August 13, 2001

SUBJECT: REVIEW OF CHEMISTRY ISSUES AND RELATED NRC STAFF CAPABILITY  
FOR THE PROPOSED HIGH-LEVEL WASTE REPOSITORY AT YUCCA  
MOUNTAIN

**Report of the ACNW Working Group on Chemistry Issues  
and Related NRC Staff Capability for the Proposed High-Level Waste  
Repository at Yucca Mountain**

Figure 1. Waste form degradation model in TSPA-SR.

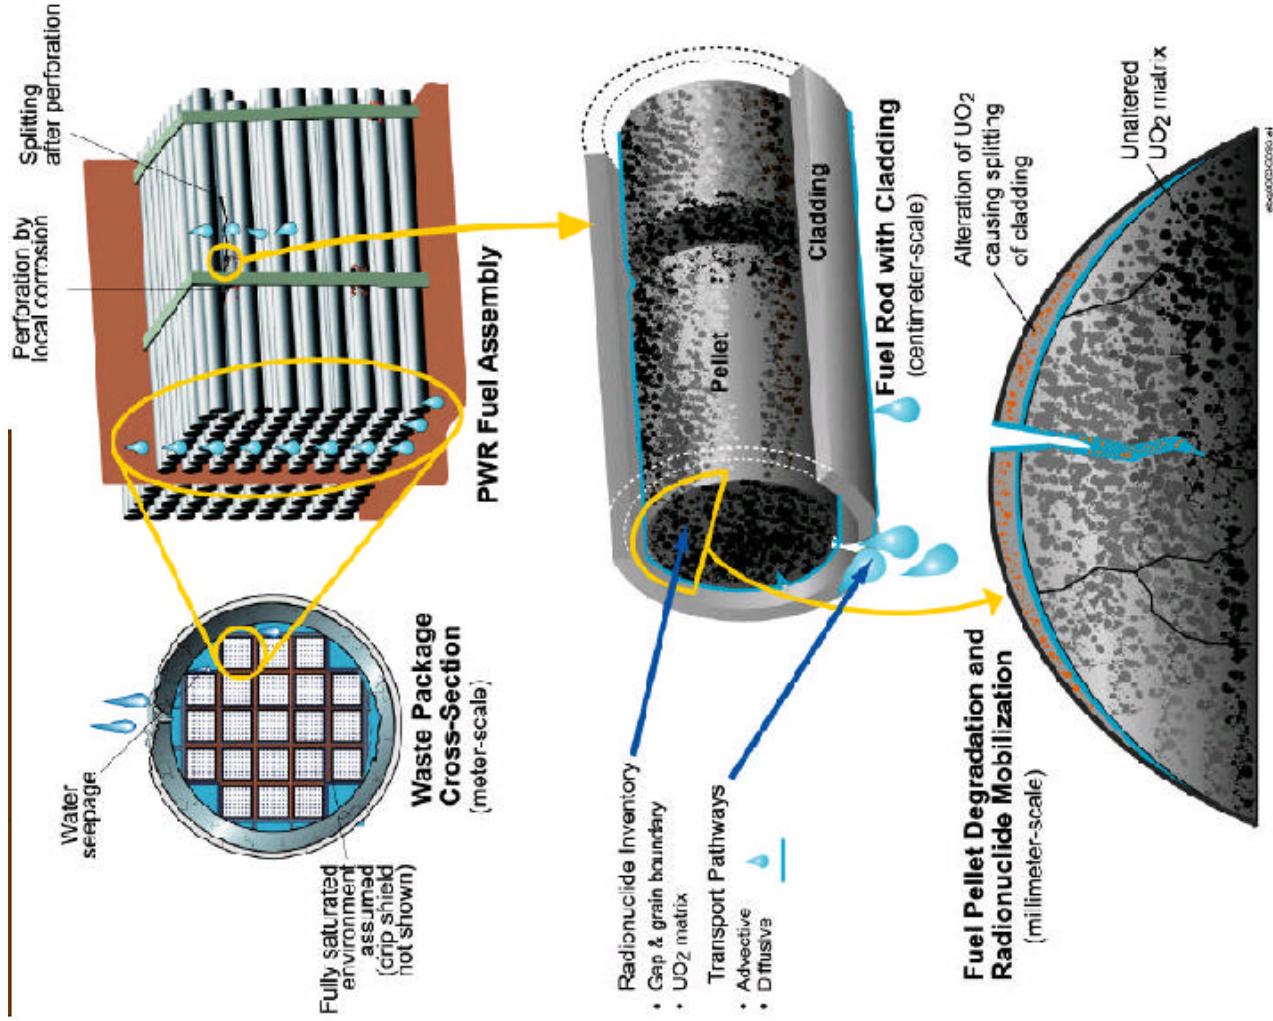
In DOE's TSPA-SR model, the calculated in-package pH<sup>vi</sup> plays a fundamental role in determining the release of radionuclides from the EBS. The pH is used in calculating radionuclide solubility (e.g., of Np), spent fuel degradation rates, which congruently releases non-solubility-limited radionuclides (e.g., of Tc and I), HLW glass dissolution rates, and the stability of colloidal species (e.g., of Pu). The calculated pH thus serves as a "master variable" controlling the release of the most significant radionuclides in TSPA-SR.

among the material reaction rates and the overall pH is fundamentally nonlinear, and uncertainties, such as in those in the thermodynamic data bases, may strongly affect the calculated pH, and consequently the calculated chemical effects, in unanticipated ways. Moreover, coupled THC interactions between the water and the degrading materials at temperatures above ambient have been ignored. In addition, no comparisons with laboratory, field, or analog data are made to provide confidence that the approach used by DOE in fact bounds the pH values that could be expected to occur in the waste package. Because of the significant impacts on radionuclide release rates and transport properties, the coupled processes affecting pH need to be more carefully evaluated and the evidence bases supporting the approach need to be thoroughly described and documented.

Finally, abstraction of the pH into the TSPA-SR model relies on a complicated mix of response surfaces for shorter time frames and linear extrapolations for longer time frames.<sup>22</sup> The TSPA-SR abstraction for pH is focused on bounding the variability from the process model calculations. DOE assumes that the variability in the pH results obtained for a limited number of equilibrium chemistry model (EQ3/6) calculations represents the uncertainty of the in-package pH. While the response surface abstraction into TSPA-SR may bound this variability, it is not clear that the abstractions capture the important uncertainties in pH.

DOE makes the assumption that an oxidizing environment exists within the waste packages at all times, and that this is a “conservative” assumption for times when most of the metals are still present and the ingress of water and gases (e.g., O<sub>2</sub> and CO<sub>2</sub>) would be limited by the slow development of general corrosion “patches” on the waste packages. In the current modeling

approach the chemical state of the water is set to be fully oxidizing by setting the partial pressure of dissolved oxygen in the water to a constant value that is representative of equilibrium with oxygen in air. Most of the important stable radionuclide solid phases under oxidizing conditions have significantly higher solubilities than the stable solid phases under reducing conditions.<sup>viii</sup> Aqueous corrosion of steel in the waste package could have a significant effect on radionuclide solubilities by producing a reducing environment when the ingress of oxygen is limited (e.g., from closure to well beyond the first 100,000 years of repository life). Redox gradients within the waste packages are acknowledged as possible by DOE. Taking credit for consumption of oxygen relative to the ingress of oxygen would require coupling chemical reaction kinetics with water and gas exchange through waste package breaches. At this time, no attempt has been made to evaluate or bound this scenario and so no conclusions can be made about the impact of this “conservatism” on radionuclide release rates.

The DOE assumption of an oxidizing environment, however, is not carried through the analysis in a consistent fashion. For example, it is assumed that the ionic species for I and Tc are in their most mobile forms -- iodide ( $I^-$ ) and pertechnetate ( $TcO_4^{2-}$ ). If oxidizing conditions prevail, however, the predominant iodine species may be iodate ( $IO_3^-$ ), which is capable of reacting with many materials in the EBS and natural environment. The assumption that iodide species prevails is inconsistent with the assumed chemical conditions.
